**DATE:** May 3, 2019  
**TO:** Steve Arnold, A-Team  
**FROM:** City of Cascade  
**SUBJECT:** **Cascade River Ranch Applications Submittal: City Comments**

SUBJECT: NWW-2019-0103-B03, Cascade River Ranch, Mixed  
Residential/Commercial Development, North Fork Payette River

## CASCADE RIVER RANCH

**Subject: River Ranch PUD Preliminary Plat Application**

**FIGURE D103.1  
DEAD-END FIRE APPARATUS ACCESS ROAD TURNAROUND**

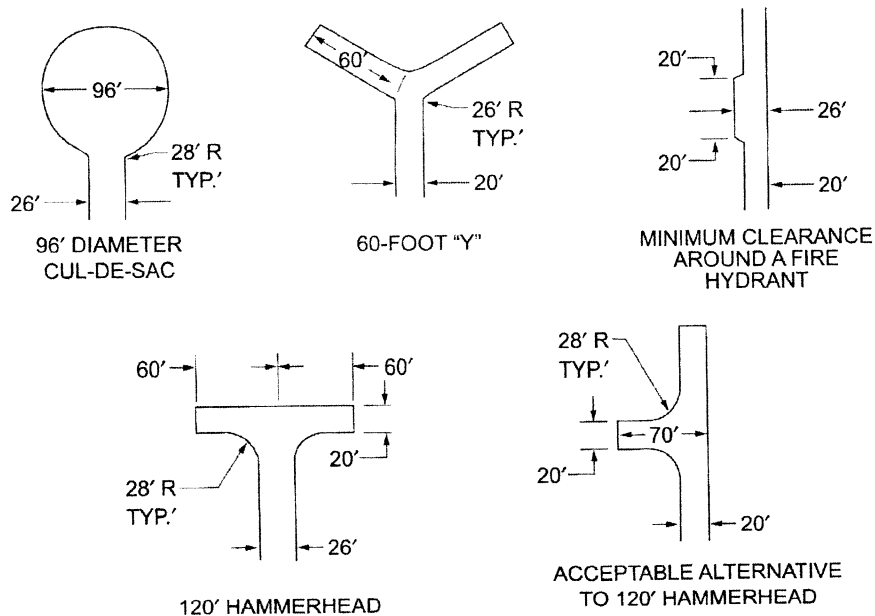
- All roads shall be built to City of Cascade standards or Section 503.2 IFC 2015.
- All dead-end road and cul-de-sac shall meet the requirements in IFC Appendix D Figure D103.1 (attached).

## Cascade River Ranch Subdivision, Cascade, Idaho

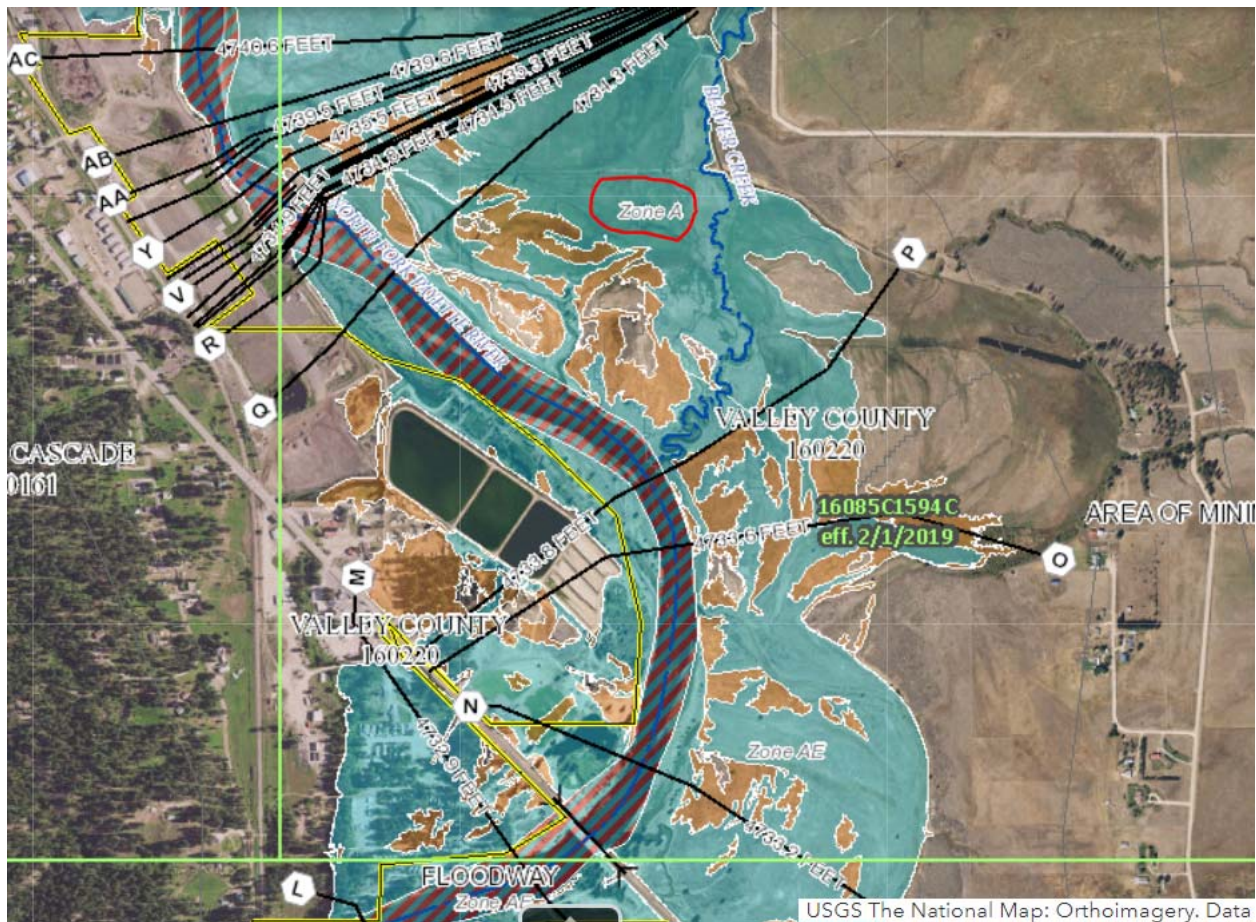
As the northern portion of the parcel is in the A Zone without BFE: BFE **must** be established before the subdivision may be approved.
